Parcel E Feasibility Study

Responses to Comments on Draft Final Parcel E Feasibility Study

Hunters Point Naval Shipyard March 29, 2012

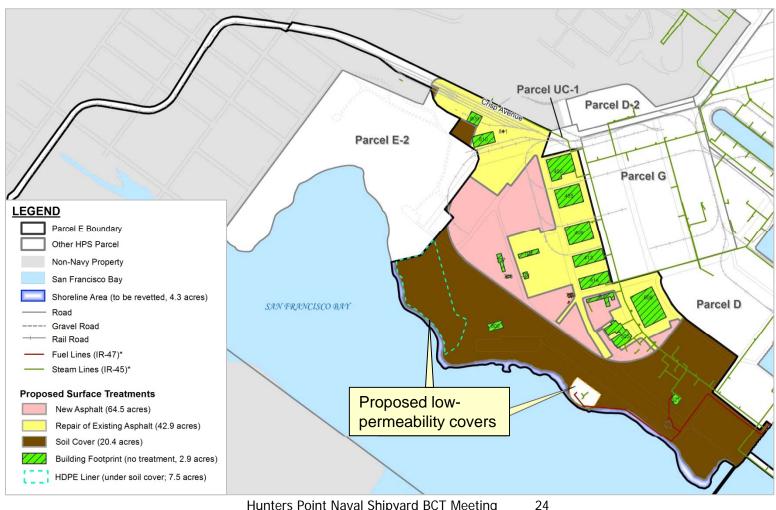
- One of the "narrative performance standards" for soil covers is the prevention of standing water.
- The redevelopment of the site intends to include some small-scale variability in hydrology within the complex of swales, shallow depressions, and upland areas on Parcel E to use these areas as stormwater treatment wetlands.

The Final FS Report will be revised to clarify that the prohibition on standing water does not apply to the soil covers in Parcel E, but only the low permeability covers proposed in IR-02 Northwest and IR-03.
